UNITED STATES PATENT AND TRADEMARK OFFICE

Office Action Summary	Application No. 10/772,960	Applicant(s) HODSON, KENNETH GEORGE	
	Examiner Thinh T. Nguyen	Art Unit 2818

DETAILED OFFICE ACTION

FIG. 8

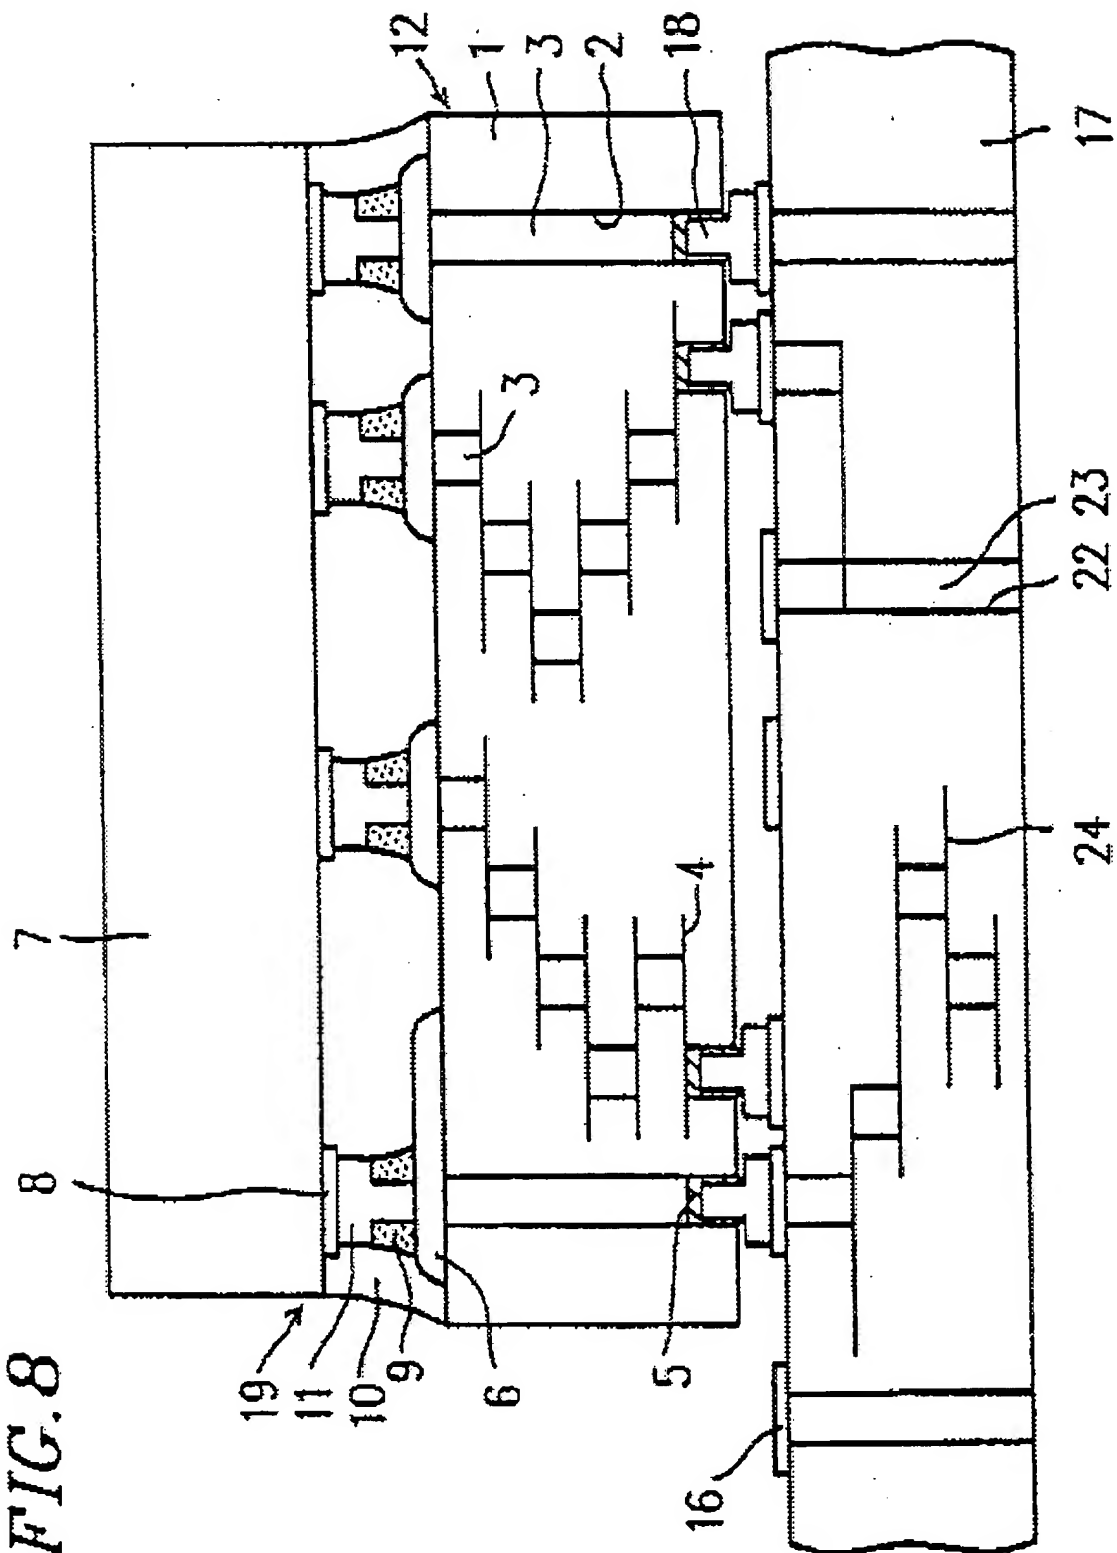
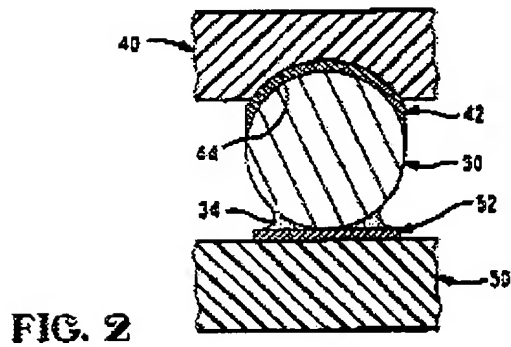
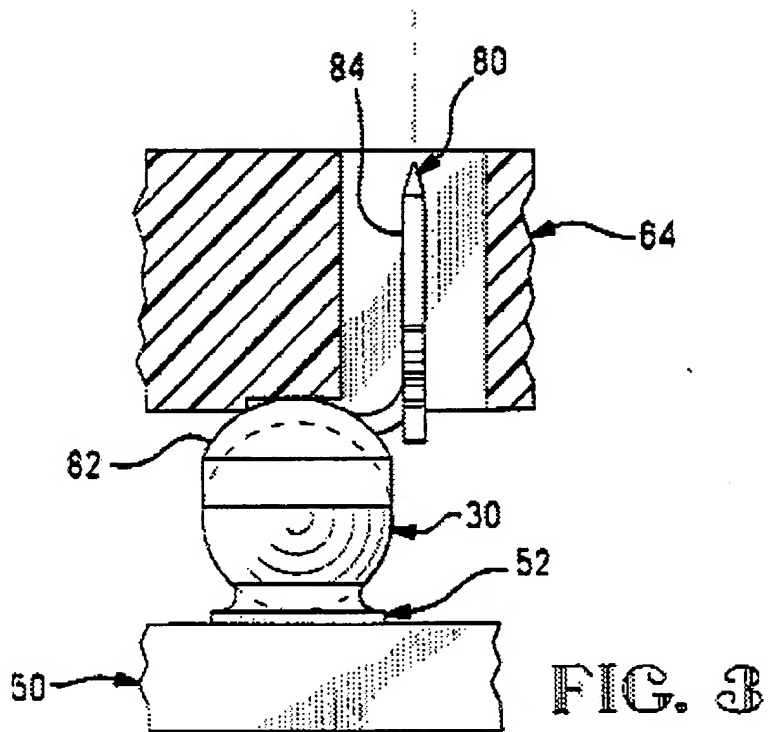
Tomura discloses (the abstract, fig 8, claim 7) a semiconductor assembly (fig 8 comprising: a IC (fig 8 reference 19) having a plurality of metallic sockets (fig 8 reference 5) arrayed on a mounting surface; a PCB (fig 8 reference 16) having a plurality of metallic projections arrayed on a mounting surface; wherein the PCB and IC are positioned so that a plurality of the sockets adjoin a plurality of the projections; and a plurality of solder joints coupling the IC sockets adjoining the PCB projections.

Tomura discloses (the abstract, fig 8) a semiconductor assembly wherein the solder joint are detachable.

Tomura disclose (in fig 8 , column 10 lines 63-65, in column 11 lines 35-39) that the projection on the PCB (the terminal electrode 18, the electrode pads 16 can be any platable metal and solder) therefore it inherently include high melting solder.

Tomura discloses (the abstract, fig 8, claim 12) a semiconductor assembly wherein the projections on the mounting surface of the PCB further comprise metallic nodes (fig 8 reference 18) affixed to selected locations on the PCB.

Tomura (in the Abstract, in fig 8) discloses all the inventions of claim 22,23,24 except That his invention can specifically be used in a BGA package. This limitation, however is in the preamble of the claims and therefore has no patentable weight. Moreover, Tomura discloses that his invention use flip-chip (column 3 line 49) and the use flip-chip associated with BGA package has become old and well known in the art.
